2.2.2 AMENDMENT 10: CPH

APPROVED ELEVATION
Drawing: 19556-CPA East Elevation

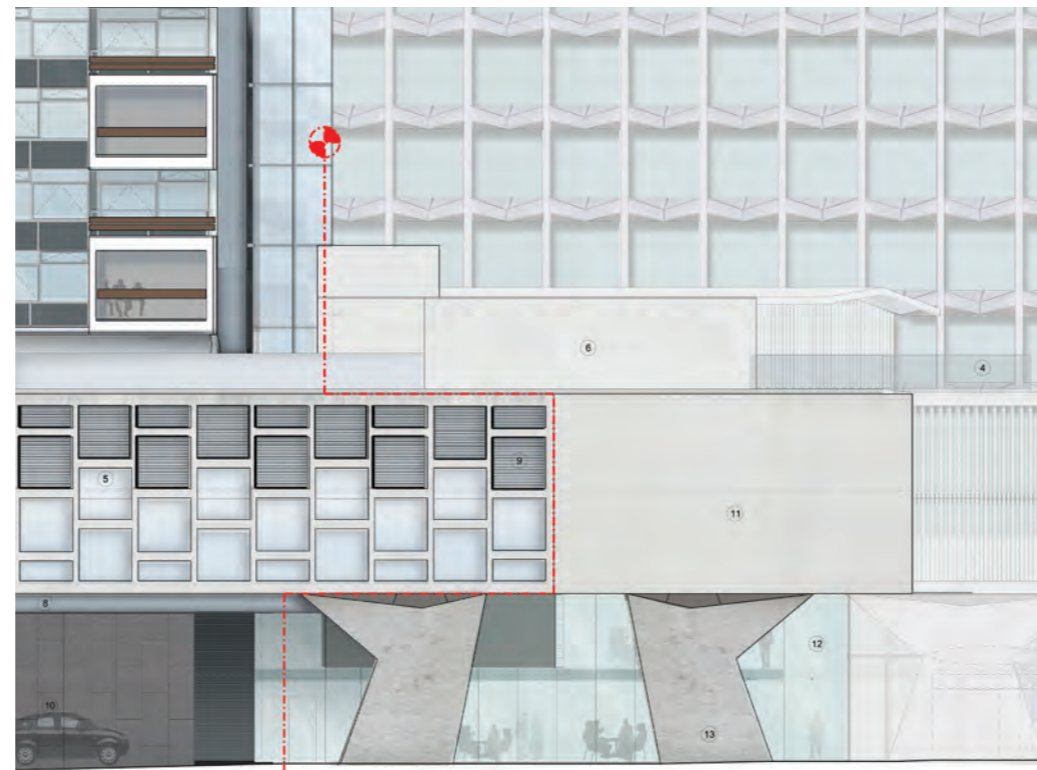
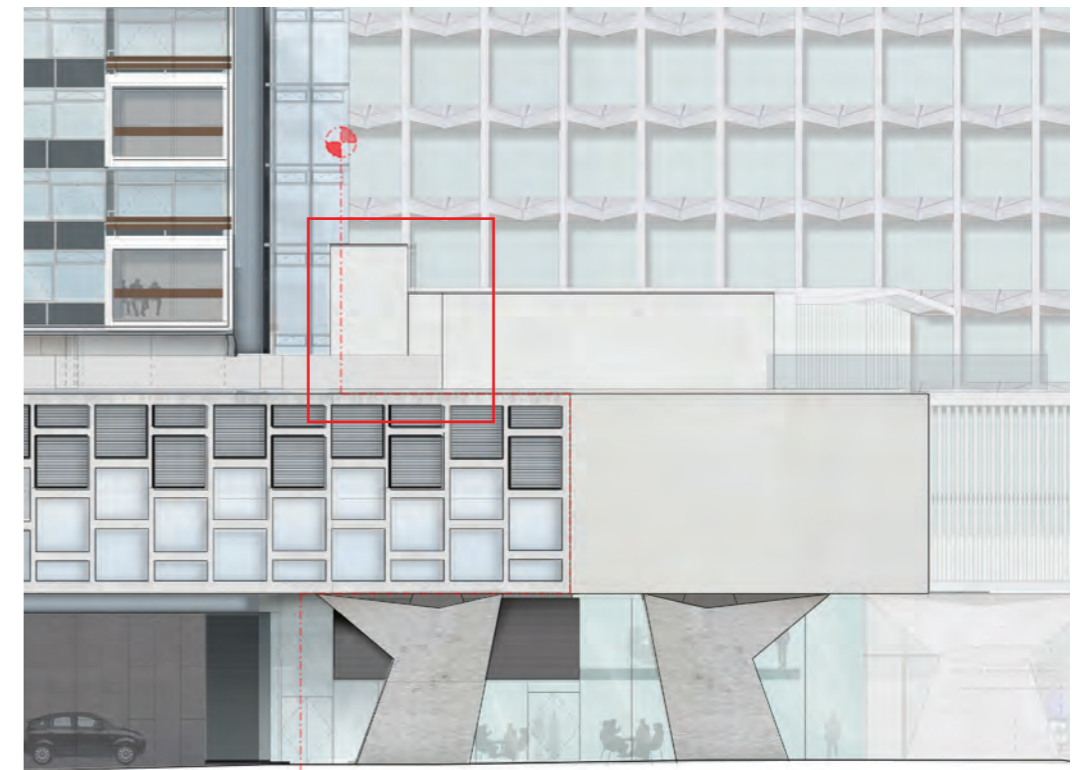
Lifts 07 & 08 realigned and cladding reconfigured

The permitted scheme contained an inconsistency between the plan layout at level 02 and the East elevation around lifts 07 & 08 at the junction with the new retail unit. There was an incorrectly noted coping line on the elevation which is to be omitted and the width of the lift shaft has been corrected to match the plan.

Additionally, the cladding face immediately adjacent to the lifts is set back to provide both a visual break between the lifts and retail unit and to conceal a necessary structural movement joint between the two structures.
